**Department of Energy**

Enclosed are the review results for Environmental Management (EM) site evaluation reports of facility ventilation capabilities performed by Headquarters (HQ). Deliverables for high priority facilities were provided by the Department of Energy's letter dated June 8, 2007; updated information is provided in Enclosure 1. These reports fulfill commitment 8.6.5 of Defense Nuclear Facilities Safety Board (DNFSB) Recommendation 2004-2, *Confinement Ventilation*.

DEFENSE NUCLEAR FACILITIES SAFETY BOARD RECOMMENDATION 2004-2
ENCLOSURES

ENCLOSURE 1**Summary of Deliverable Actions Determined by Environmental Management
Headquarters' Review****High Priority Facilities****Waste Treatment Plant (WTP)**

Figure 5 242-A Evaporator K1 Exhauster (Upgrade)

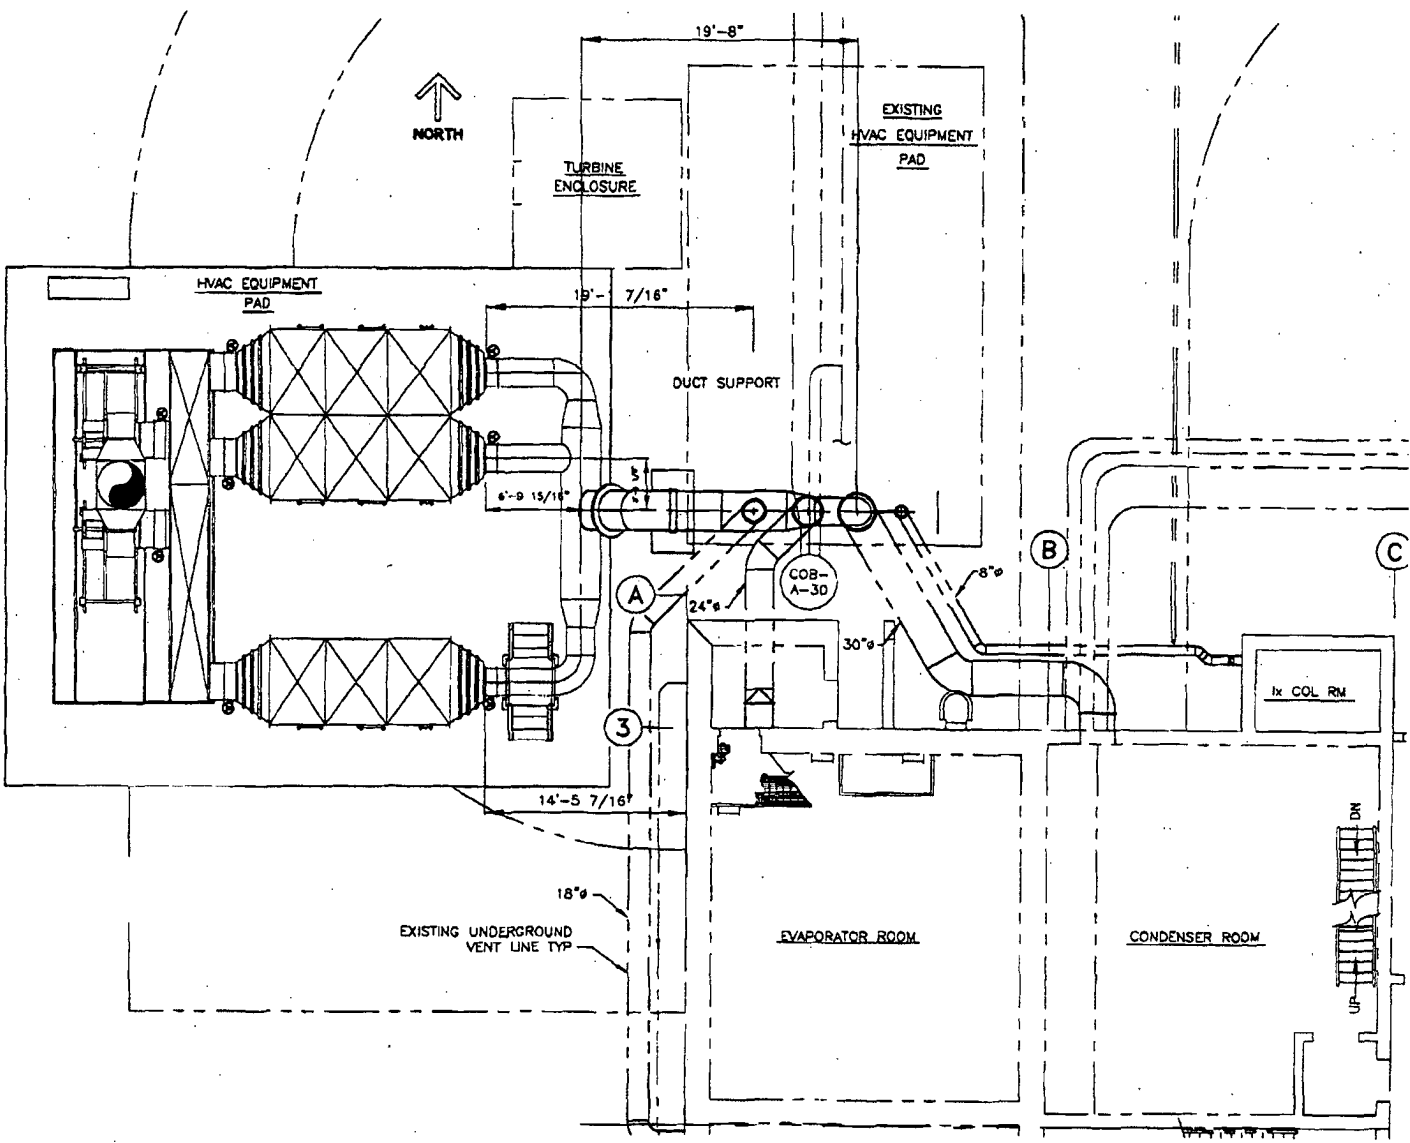
Two gaps were identified that will remain. Fire suppression features have not been provided inside HEPA filter housing as recommended by DOE-STD-1066, *Fire Protection Design Criteria*, and following modification the underground duct work may be vulnerable to a seismic event. The ventilation system is not credited in the DSA to operate or maintain confinement integrity during or following any DBA or NPH events.

A cost/benefit analysis was not performed to replace the underground ducting due to the extensive nature of the modification and the fact that addressing the gap would provide limited, if any, overall dose reduction. With respect to fire protection of the filter housing, a revision to the FHA will document any gaps with DOE-STD-1066 and ORP approval will be required for any associated equivalency(s) and/or exemption(s). A rough order of magnitude cost estimate was performed for adding a deluge system to the

planned modification. The design and installation was estimated at \$1.1 M which does not include costs for cold weather protection and the significantly increased lifecycle cost for surveillance of the system. Additionally, a deluge system will introduce the potential for flooding from inadvertent system activation or leaks, and worker exposure from routine operations to maintain the deluge system. The FET does not recommend any changes to the planned modification.
